UNITED STATES PATENT AND TRADEMARK OFFICE

APPLICATION NO.	FILING DATE	FIRST NAMED INVENTOR	ATTORNEY DOCKET NO.	CONFIRMATION NO.
10/729,760	12/05/2003	Kenneth C. Boyle	P06090US00	3212

FINAL OFFICE ACTION

FIG. 2

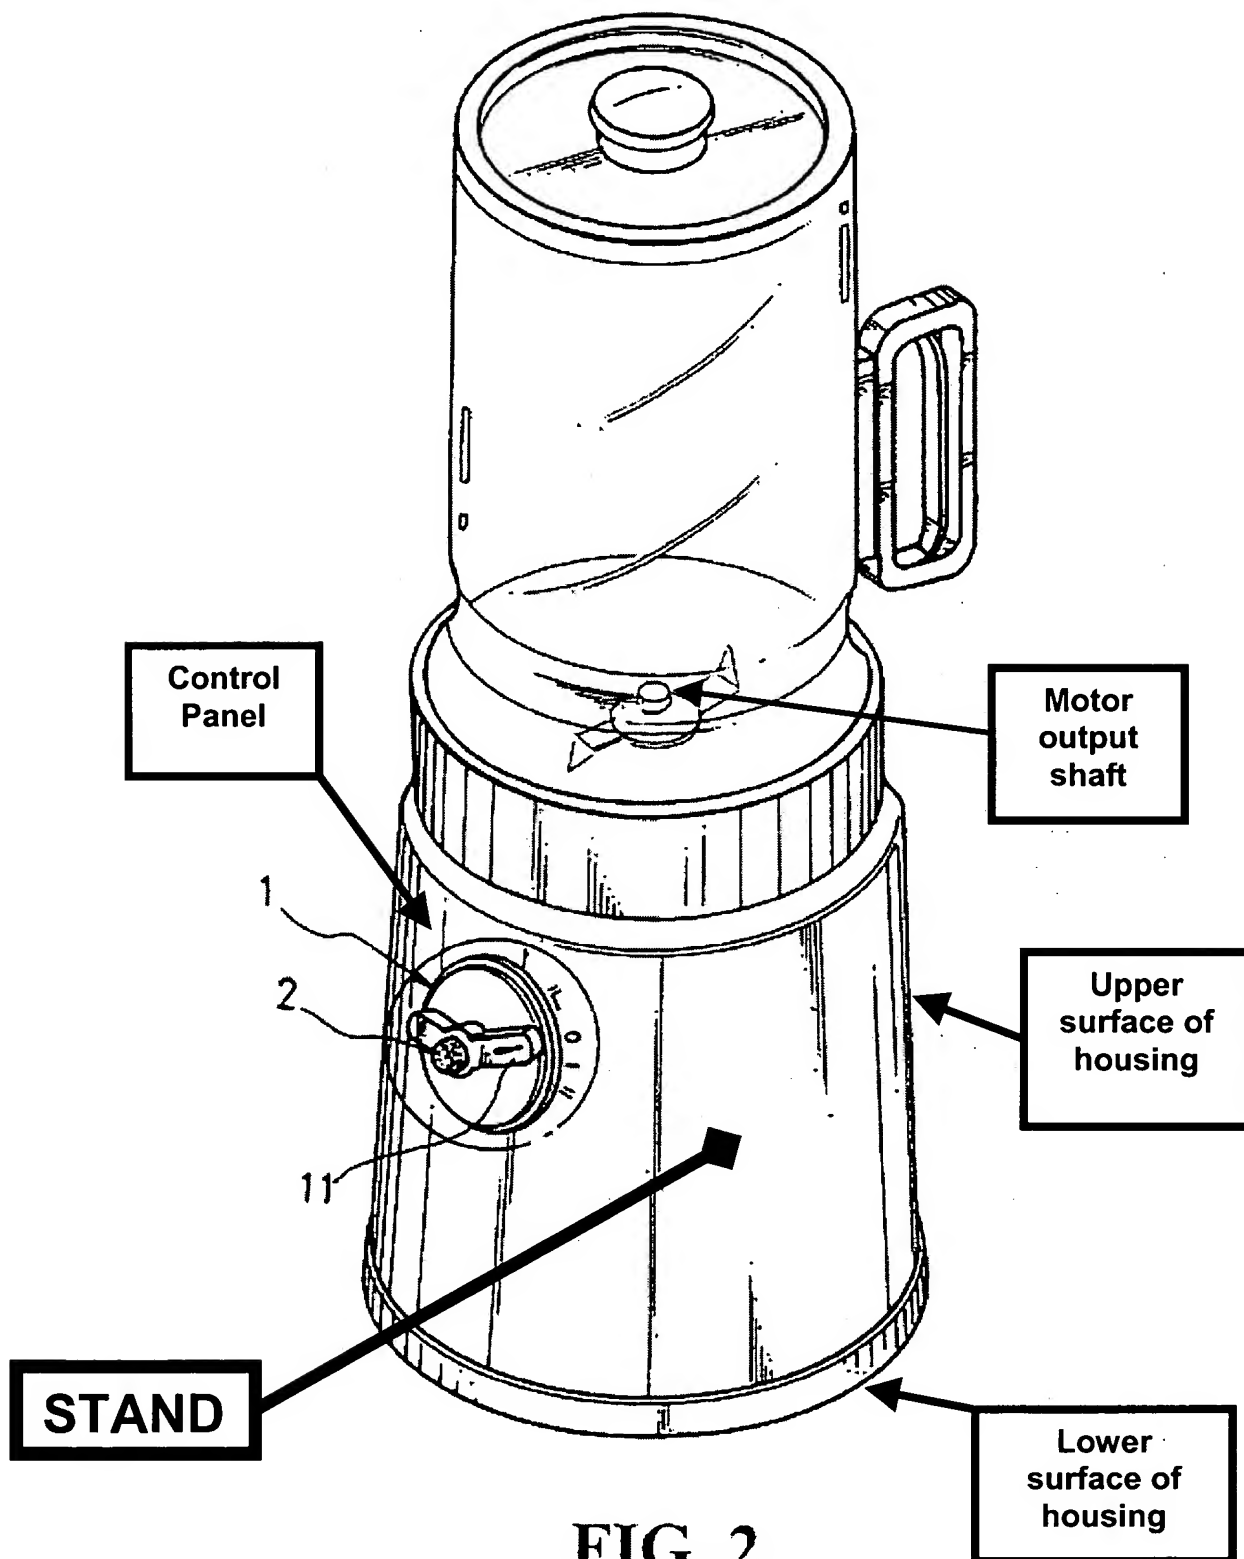
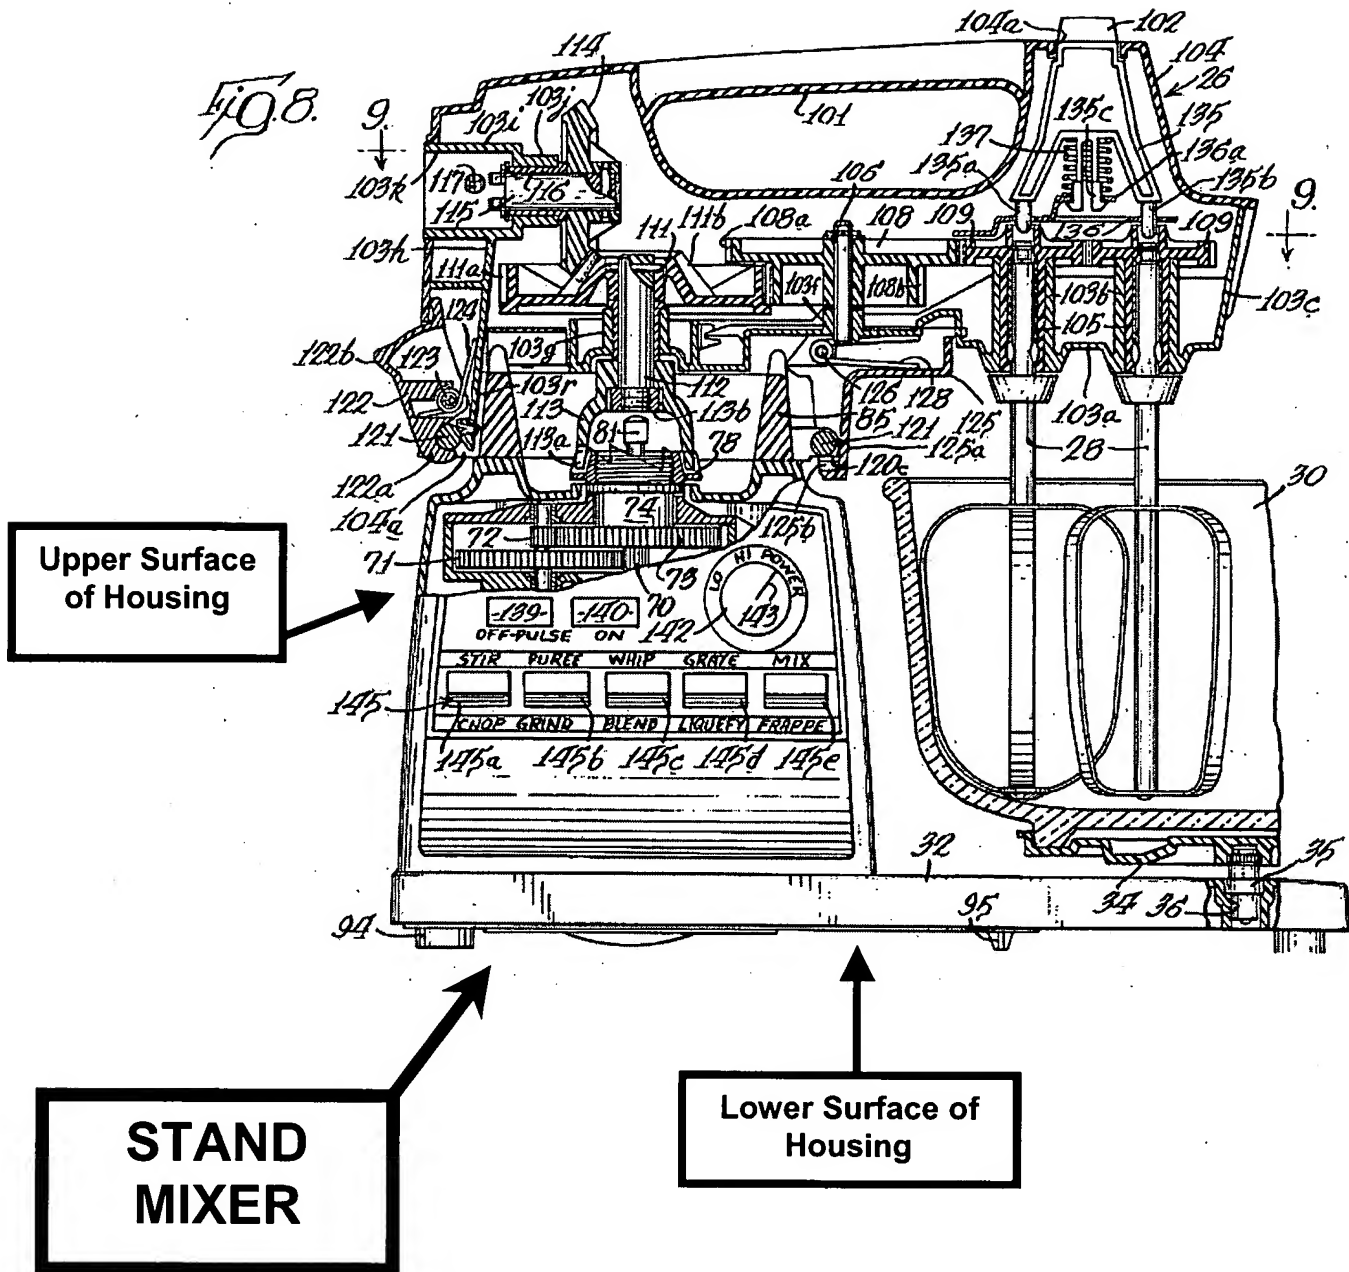
5. **Claims 1, 2, 4, 11, 12, 15, 16, 17, 18, 23, 24, 25, and 26 are rejected under 35 U.S.C. 102(e) as being anticipated by Lin (US 6,599,006 B1).**

The patent to Lin (US 6,599,006 B1) discloses a mixer control method and a mixer with a housing or stand (and thus a "STAND MIXER") as labeled below, the housing or stand having an upper surface disposed above a lower surface (as seen

below in Fig. 2); a motor within the housing connected to an output shaft; a control panel on the housing having a rotary or rotatable dial 1 that is adjustable to select an incremental motor speed and a power button 2 located in the center of the rotary dial 1 for starting the motor of the mixer; a speed indicator with multiple speed locations disposed radially from an axis of the dial as seen in Figs. 2, 3, and 5; the control panel on the upper surface of the housing; the dial having speed indicia including an off position "O" and a standby position "IL"; the power button 2 having a stop position as seen in Fig. 5; the speed indicator on the upper surface of the housing having speed indicia with multiple speed locations (the indicia "IL", "O", "I", and "II") that indicates the corresponding incremental speed of the motor.

With regard to amended claim 3, it is believed obvious that the combination of Lin in view of Piland above would inherently and necessarily locate the lens at the respective indicia "IL", "O", "I", and "II" adjacent the rotary dial 1 in Lin such that the proper indicia and corresponding speed selection is indicated to a user, via illumination of the lens. To locate the lens at other locations not specifically correlated to the speed indicia would be nonsensical.

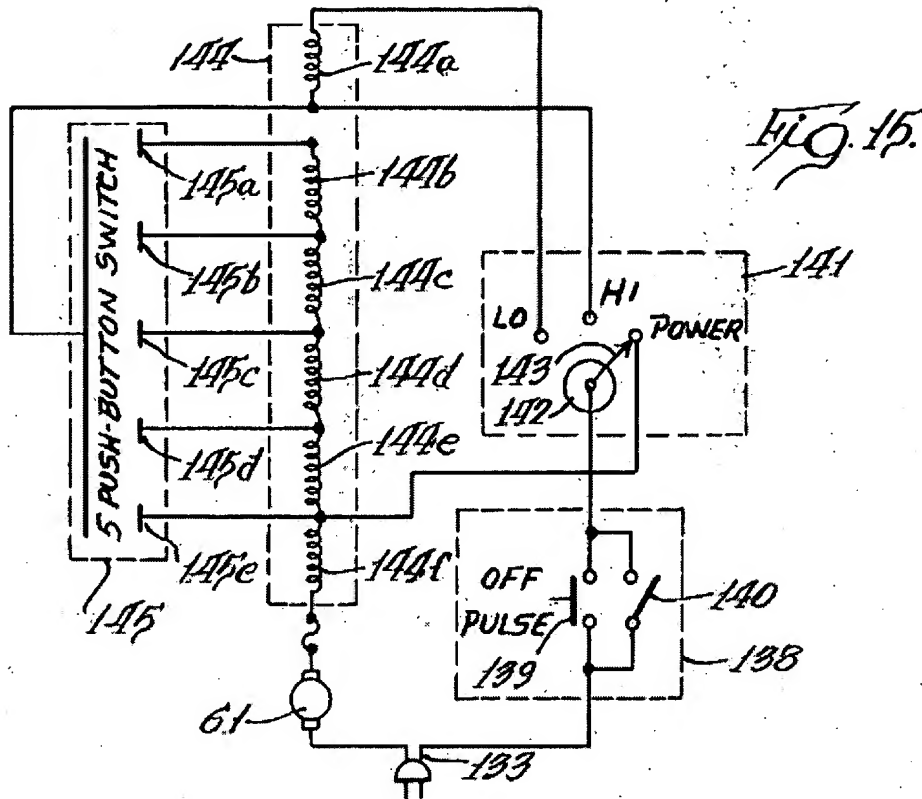
6. Claims 18 and 23 are rejected under 35 U.S.C. 102(b) as being anticipated by Ernster et al. (US 3,951,351).

The patent to Ernster et al. '351 discloses a stand mixer (Figs. 1, 2, 4, 8, and 15) with a housing 24, 32 having an upper surface (as labeled below) disposed above a lower surface 32; a motor 46 within the housing connected to an output shaft 62; a control panel (Figs. 1, 2, and 8) on the housing having a power switch 141, a rotatable speed selector 142 to change motor speed, and a speed indicator 143 with speed indicia (Fig. 8) located on the upper surface of the housing; the control panel being located on the upper surface of the housing as seen below.

7. Claims 24 and 25 are rejected under 35 U.S.C. 102(b) as being anticipated by Ernster et al. (US 3,951,351).

The patent to Ernster et al. '351 discloses a stand mixer (Figs. 1, 2, 4, 8, and 15) with a housing 24, 32 having an upper surface (as labeled below) disposed above a lower surface 32; a motor 46 within the housing connected to an output shaft 62; a control panel (Figs. 1, 2, and 8) comprising a rotary dial speed selector 142 to change motor speed; the control panel being located on a top portion of the upper surface of the housing as seen below; the control panel having a speed indicator 143 and a power button 140 actuable by a user for starting the motor 46 (see Fig. 15).
